UNITED STATES PATENT AND TRADEMARK OFFICE

| APPLICATION NO. | FILING DATE | FIRST NAMED INVENTOR | ATTORNEY DOCKET NO. | CONFIRMATION NO. |
|--|-------------|----------------------|---------------------|------------------|
| 10/822,706 | 04/13/2004 | Tomotoshi Senoh | 086142-0629 | 2928 |

| Office Action Summary | Application No. 10/822,706 | Applicant(s) SENOH ET AL. | |

DETAILED ACTION

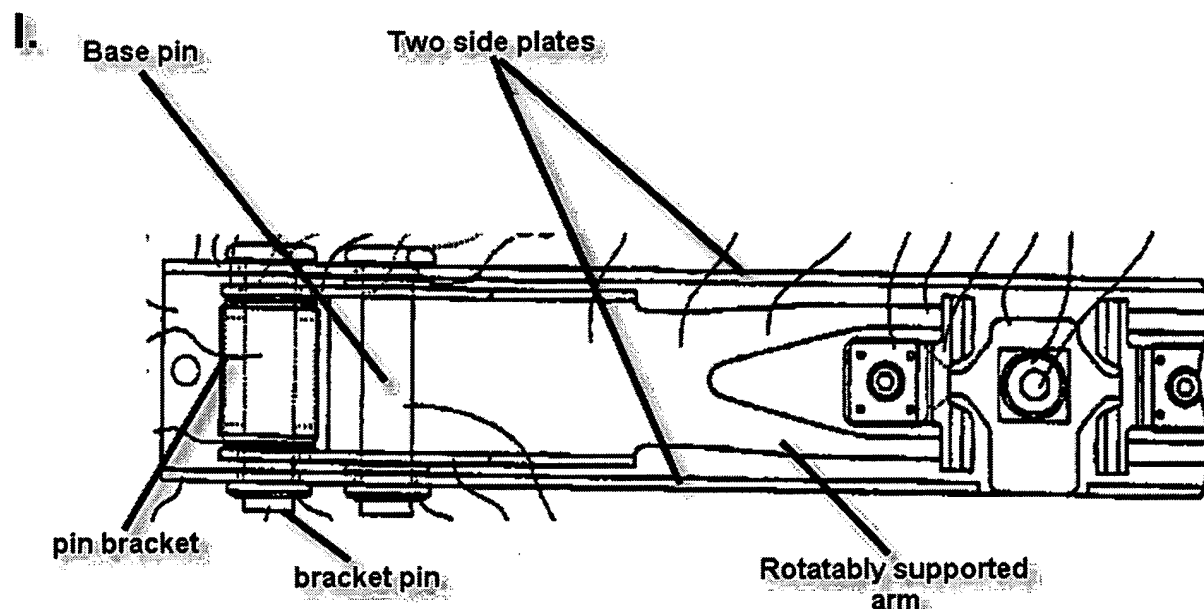
9. With respect to claim 7, Aoki discloses a device for measuring seat weight including the weight of an occupant sitting on the seat, the device comprising: a base having two side plates (see picture I. provided below); an arm rotatably supported by and interdisposed between the side plates of the base via a base pin (see picture I. provided below, and item 31 figure 4); a pin bracket in communication with the arm via a bracket pin and further adapted to be in communication with the seat (see picture below, and items 25 and 27 figure 4); a load sensor in communication with the arm; and wherein the pin bracket is located between the base pin and the load sensor. Aoki does not explicitly disclose wherein the device is configured so that the weight of the seat is applied between the at least one support point and the sensor point.

12. With respect to claim 10, Aoki discloses the device of claim 7 (see 103 rejection above), wherein the pin bracket is rotatably supported by the base pin ((figure 4 and column 2 lines 25-30 and see picture I. provided above.)

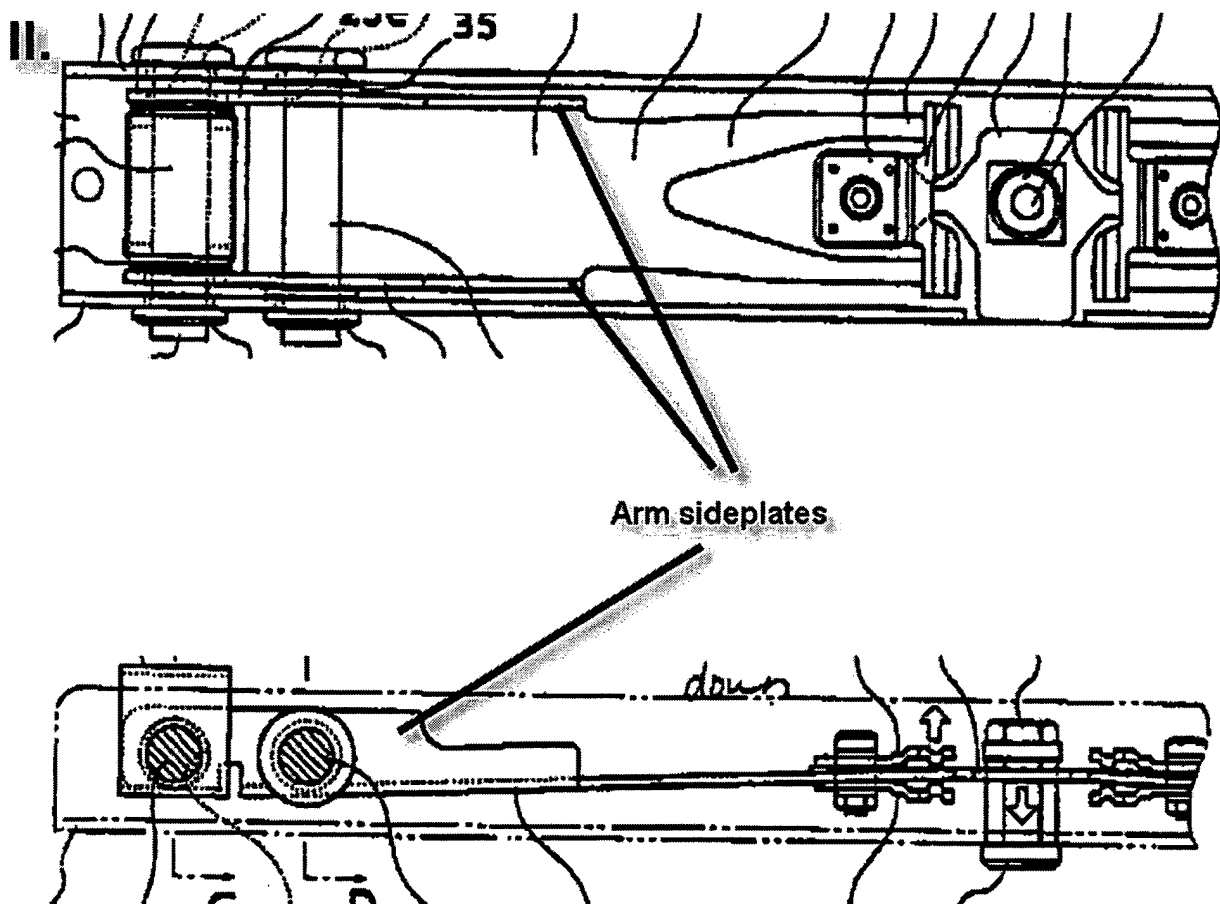
14. With respect to claim 12, Aoki discloses the device of claim 7 (see 103 rejection above), wherein the arm comprises two arm sideplates (see picture II. provided below.)
